Modification Recommended Service Note

N8934A - Autoranging System DC Power Supply, 500V, 90A, 15000W, 208 VAC

Serial Numbers: DE14290000 - DE15369999 without manufacturing ID Version "B"

5) SMT resistors R93/94 are located in red circle shown below:

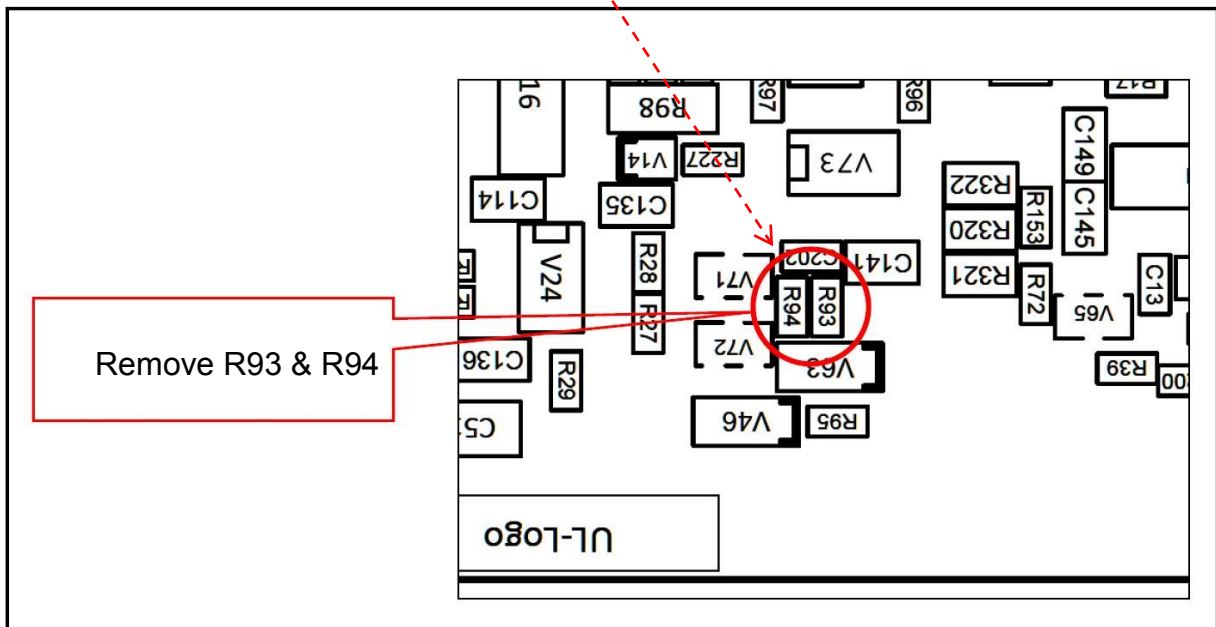
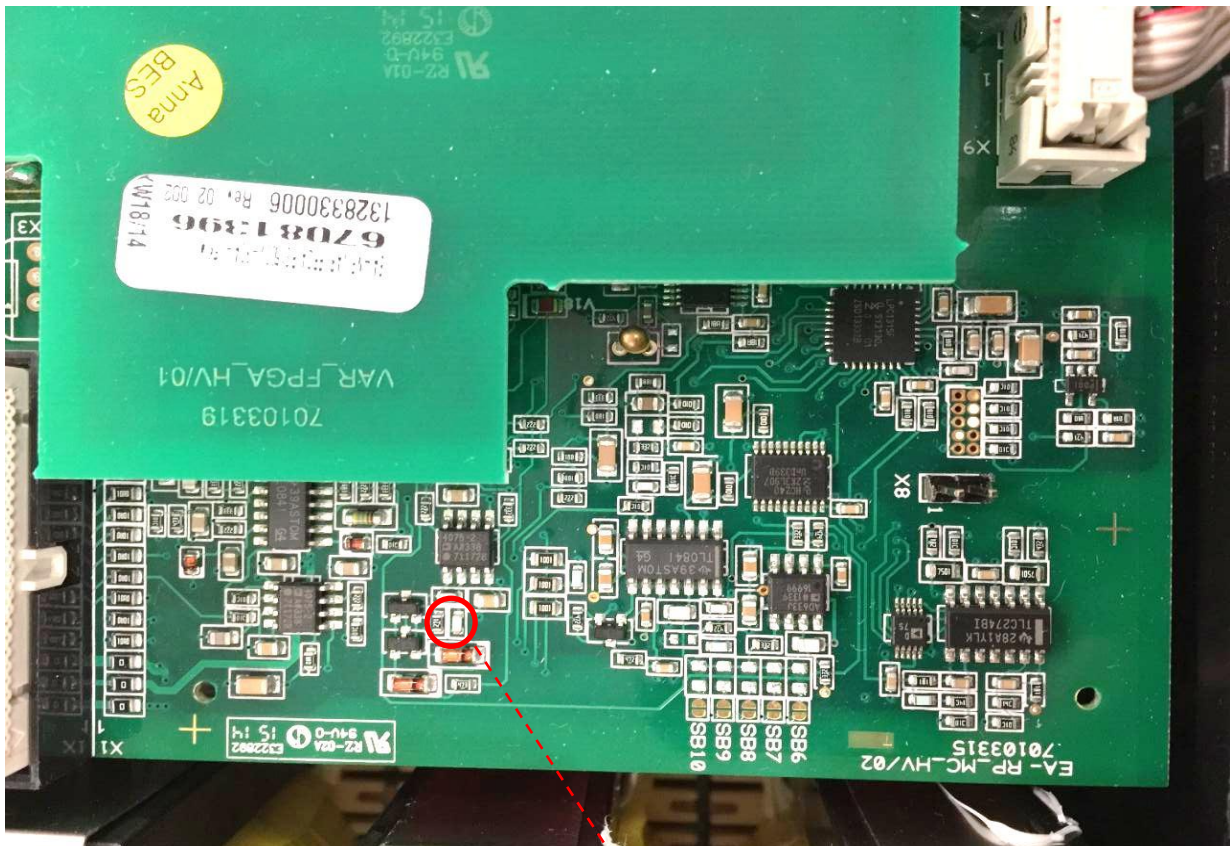
Resistors R93 and R94 must be removed, no replacement parts are required for modification.

Removal of two (2) surface mount resistors, R93 and R94, will correct this problem:

6) After removal of R93 & R94, re-install all covers. Instrument does NOT require recalibration after the removal of R93 & R94.

Suffix “B” added

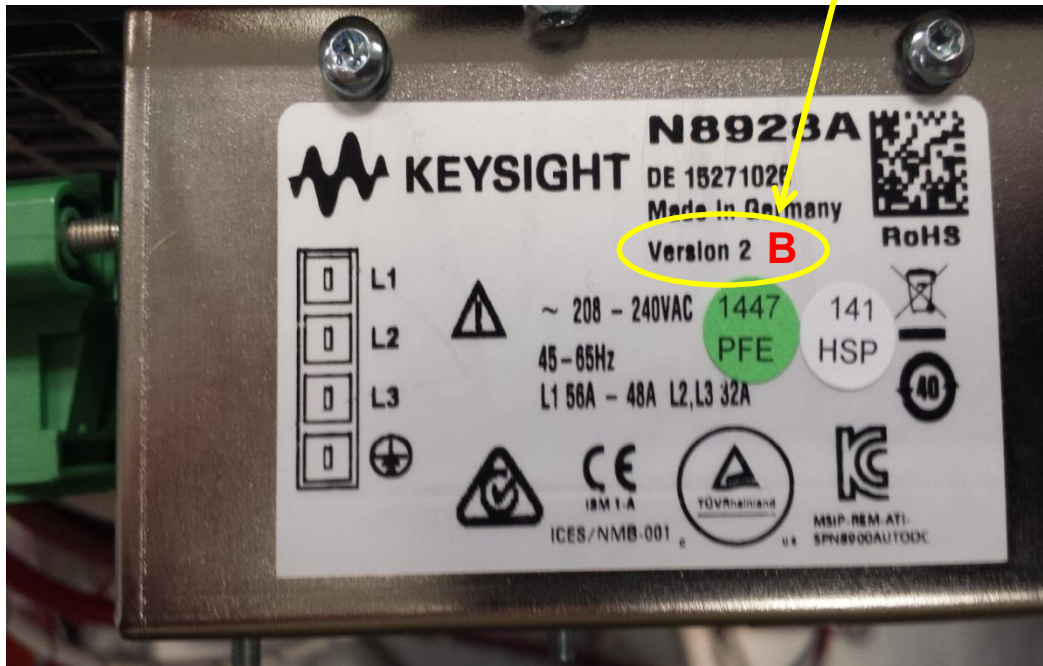
7) On the acMains label, on the rear of the instrument; use an indelible marker, to add the suffix letter “B” after the Version ID. This will assist in the tracking of modified instruments.
